Contract #: 04-0120F4Cty: SF/ALA Rte: 80 PM: 13.2/13.9File #: 69.25B**QUALITY ASSURANCE -- NON-CONFORMANCE REPORT****Location:** Changxing Island, Shanghai, P.R. China**Report No:** NCR-000379**Prime Contractor:** American Bridge/Fluor Enterprises, a JV**Date:** 06-Aug-2009**Submitting Contractor:** Zhenhua Port Machinery Company, Ltd (ZPMC), Changxing Island**NCR #:** ZPMC-0353**Type of problem:**

Reference Description: Missed MT Indication in the base metal on CB6 Intermediate Diaphragm**Description of Non-Conformance:**

Job Name: SAS Superstructure

Subject: NCR No. ZPMC-0353

Reference Description: Missed MT Indication in the base metal on CB6 Intermediate Diaphragm

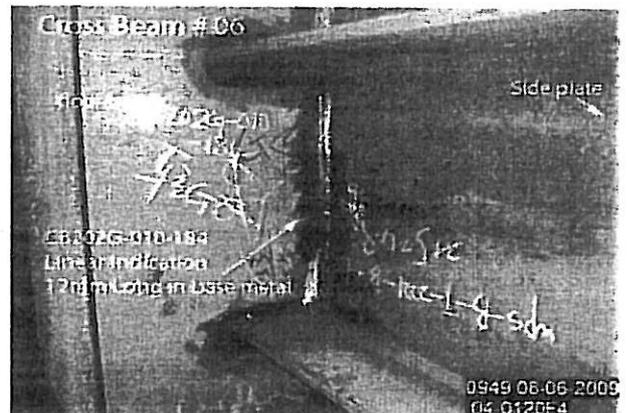
During random verification of Magnetic Particle Testing (MT) at OBG Cross Beam # 06 Intermediate Diaphragm. Caltrans Quality Assurance (QA) Inspector discovered a 12mm long linear indication in the base metal near the weld (CB202G-010-184). These areas were previously tested and accepted by ZPMC Quality Control MT Technician.

AWS D1.5 (02) Section 6.26.2 – “Welds that are subject to MT in addition to visual inspection shall have no cracks”

Repair indication and perform required NDT.

Contractor submitted CWR along with NDT documentation verifying the repair is in conformance with Contract requirements. QC NDT Technician also received additional training.

WELD NUMBER: CB202G-010-184

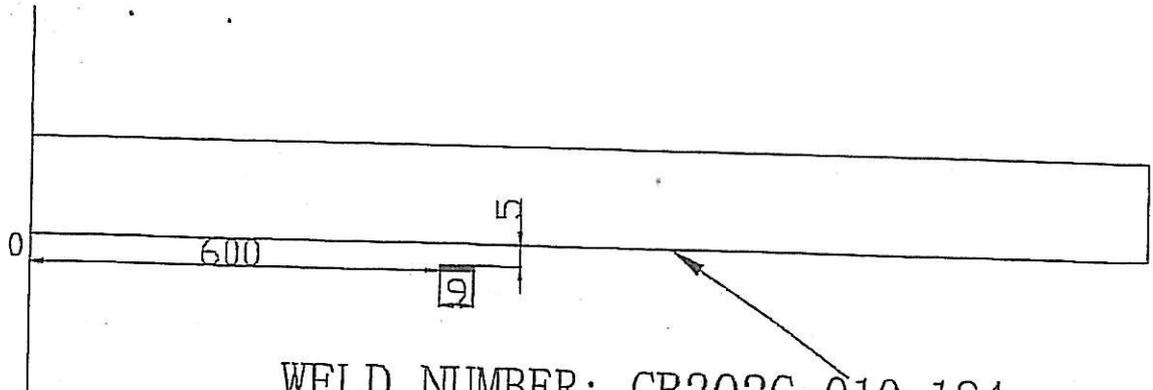
在对CB202G-010-184检测时, 发现1处纵向裂纹.

One longitudinal crack was found by use of MT on CB202G-010-184.

1. 火焰加热时, 水汽没有完全的去掉或者这个区域预热不够;
1. Moisture wasn't completely removed during drying operation (preheating) or the area wasn't preheated sufficiently.

1. QC and a Lead CWI shall be present, direct and supervise all grinding and welding operations during this repair to ensure the repair is per the disposition requirements.

2. QC and a Lead CWI shall have an approved copy of the CWR in hand prior to the repair.
 3. Remove paint ≥ 25 mm in all direction of HAZ prior to MT.
 4. Remove cracks by grinding. Repair area shall extend a minimum of 50mm beyond each end of single crack repairs.

5. Perform hardness testing at repair area and base metal laying abroad cracks, provide verbal and written notification to Engineer prior to performing hardness testing, and submit the testing result to Caltrans for review prior to repairing after testing.

6. Perform base metal repair work as follows if base metal damage protrudes into the surface more than 3mm.
 7. Prepare excavation in accordance with an approved repair WPS prior to welding.

8. Before this repair, Verify with VT and MT repair areas are defects free.
 9. Preheat and weld according to the approved repair WPS.
 10. Grind the repaired area flush with base metal or the adjacent weld.

11. Perform relevant NDT inspection to all repaired weld (along with an additional 50mm at each end of the weld repair) as well as the weld which is in the opposite position of the repaired welds according to shop drawing and additional NDT requirement stated in special provision 10-1.59 "inspection testing" note 3 after repair.
